'THE OLD PUMP HOUSE', LEPTON HD8 OLY

OUTLINE DRAINAGE STRATEGY FOR PLANNING

Drawing Number:  
mkcl-121- DS1

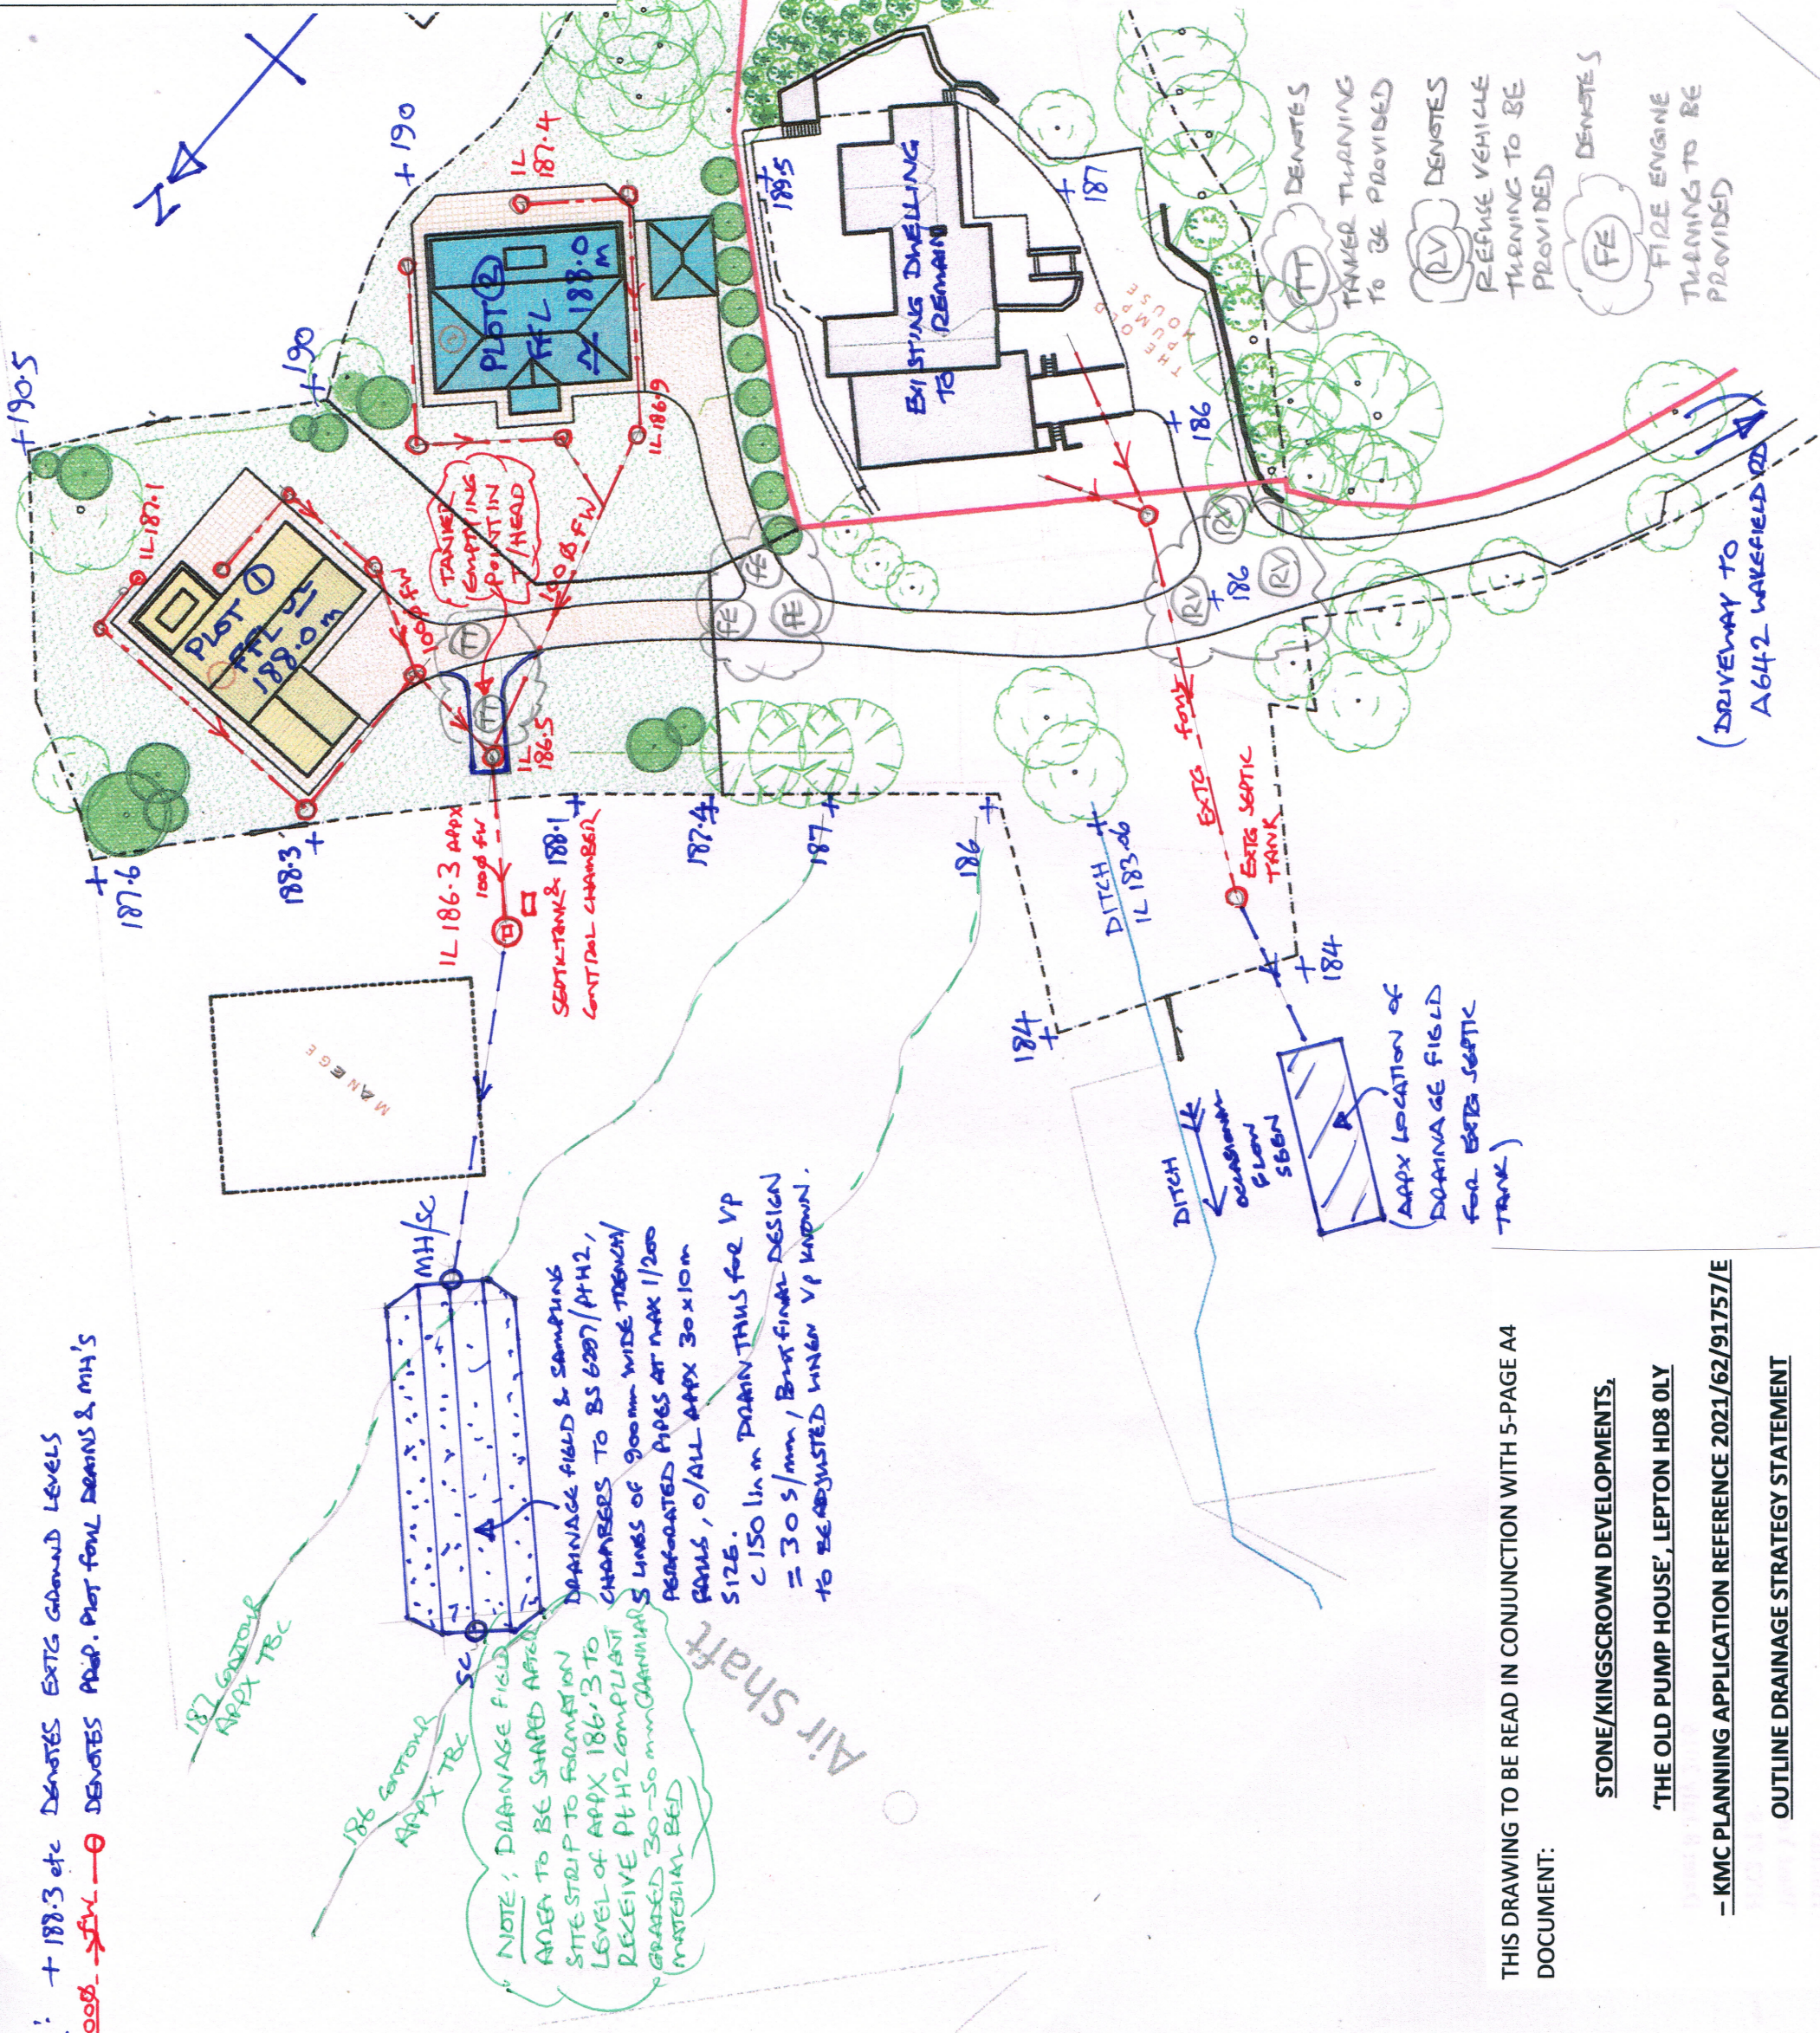
NOTE: DRAINAGE FIELD AREA TO BE SHAPED AFTER SITE STRIP TO FORMATION LEVEL OF APPX 186.3 TO RECEIVE PTH2 COMPLIANT GRADED 30-50mm GRANULAR MATERIAL BED

DRAINAGE FIELD & SAMPLING CHARGERS TO BS 6297/PTH2, PERFORATED PIPES AT MAX 1/200 FALLS, O/ALL APPX 30x10m SIZE.  
C 150 lin m DRAIN THUS FOR VP  
= 30 s/mm, BUT FINDER DESIGN TO BE ADJUSTED WHEN VP KNOWN.
